Kansas Department of Agriculture
 Division of Water Resources
CHANGE: PU WORKSHEET **& ownership ***

RE: Water Right,
File Nos. 46,205 & 47,040;
Appropriation of Water, File
Nos. 47,613 & 49,257

APPROVAL OF APPLICATION FOR CHANGE IN PLACE OF USE APPROPRIATION OF WATER FILE NO. 47,613

MARK LAWLESS
SITE MAP FILE NO. 50171 (REVISED)

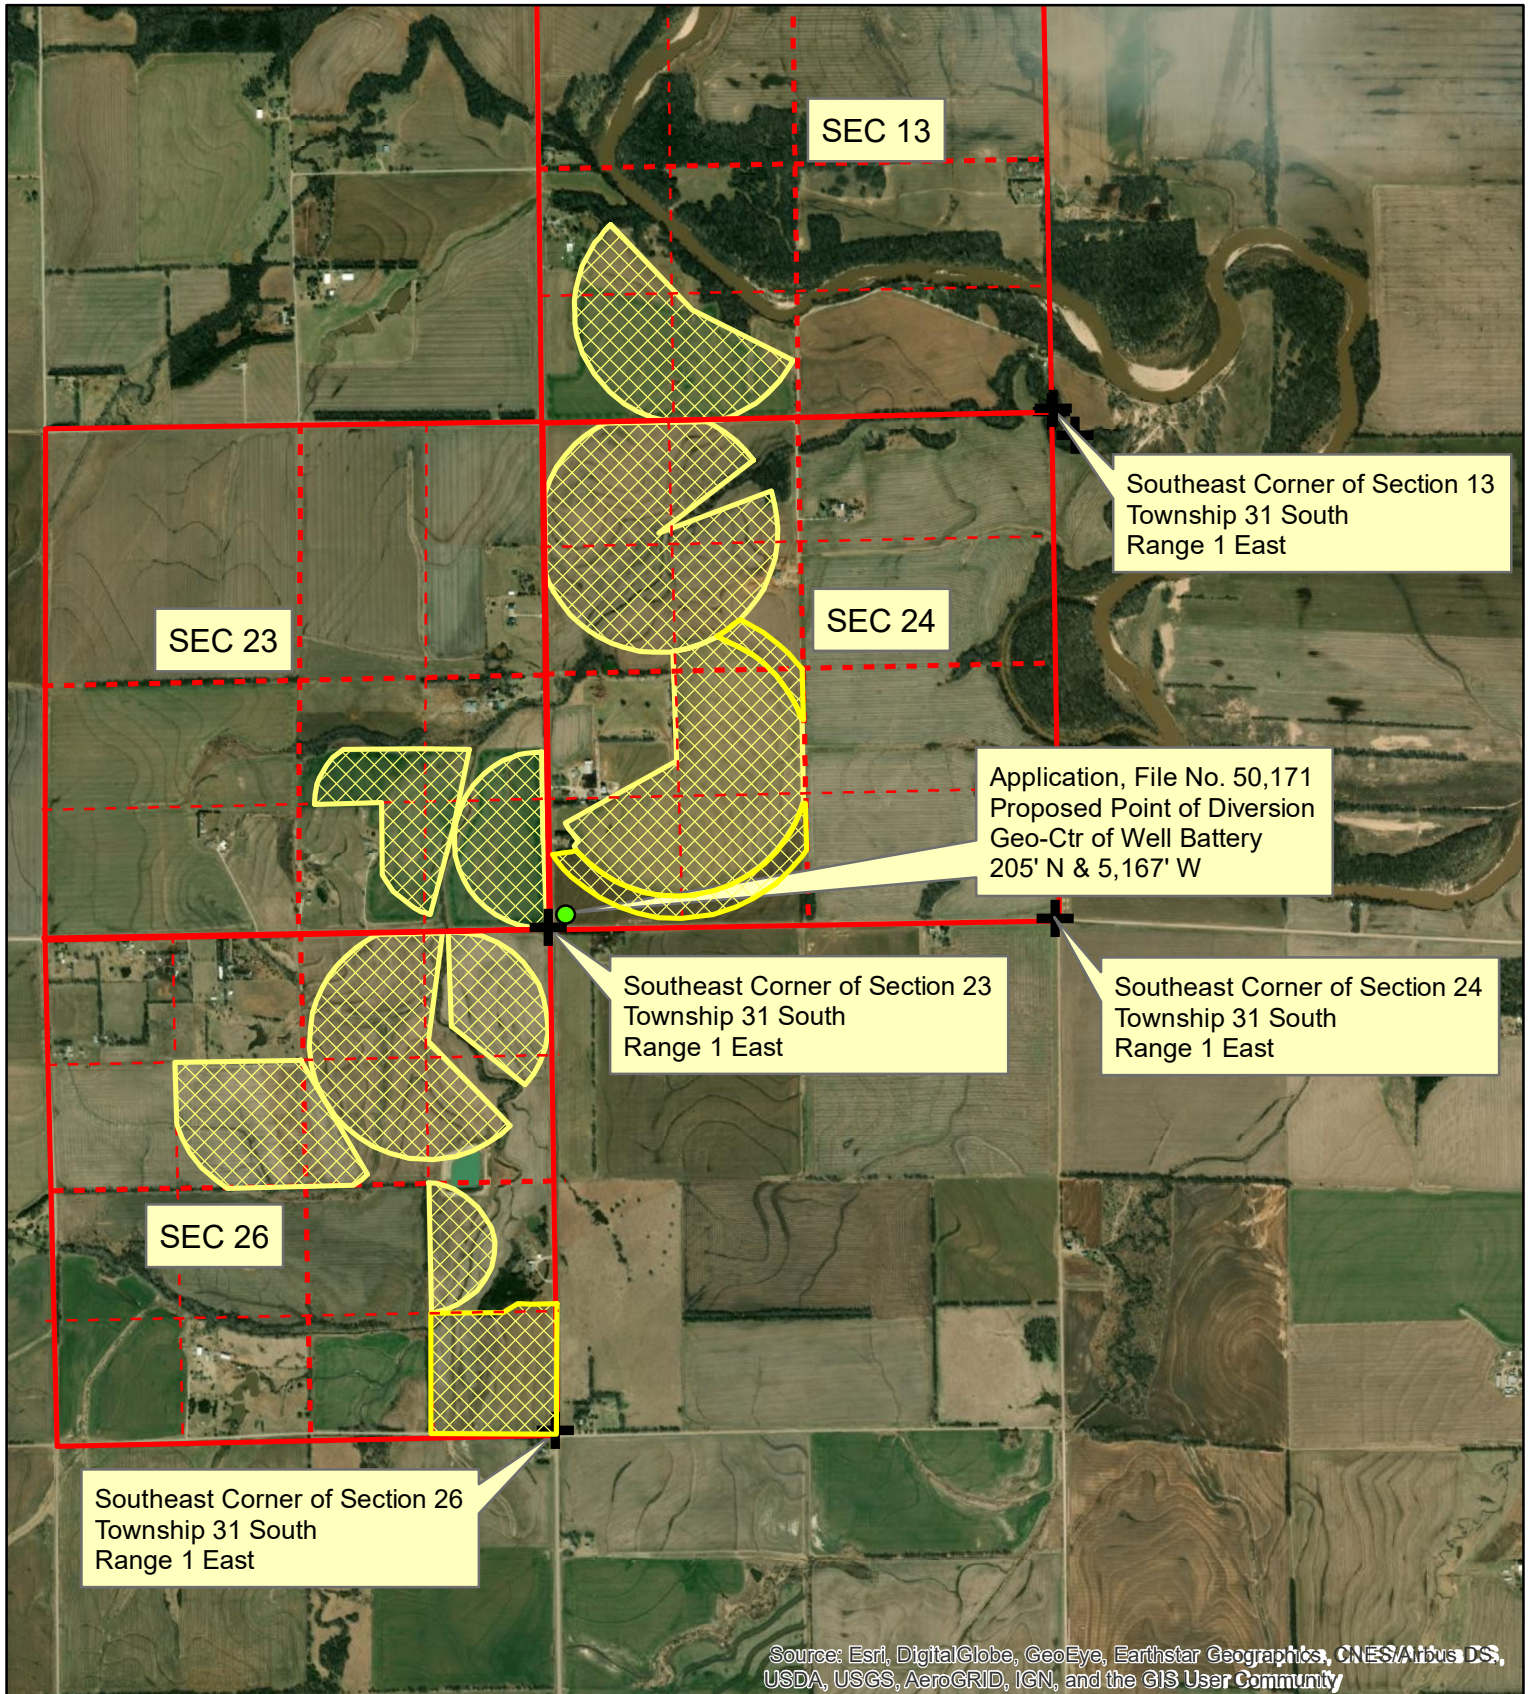
Attached is a draft memo for 50171 and the four PU changes associated – 46205, 47040, 47613, 49257. They will create a complete overlap amongst all. Doug edited 50171 down to 400 AF, which Mark signed off on. The reduced quantity freed up water for another app he had nearby, 50175.

Bumped 49834 (in two mile circle) up to the top of our list for final review. Will need to be signed before we approve 50171.

There will need to be a quantity limitation on 50171, when combined with the four senior files, correct? I'll need to add a bit to my memo before calling it a final draft..

Ya. I think Matt was wrong on 49834. But it does look like we separated out the terrace deposits and the alluvium in both SY's. The GIS alluvium extent confirms. Did Doug have anything on the source here? The Geology layer calls it Loess.

I agree with your safe yield extent.

Of course there are no water levels nearby to hang our hat on. I think you can approve this package.

Yes I believe you will need an overall limitation.
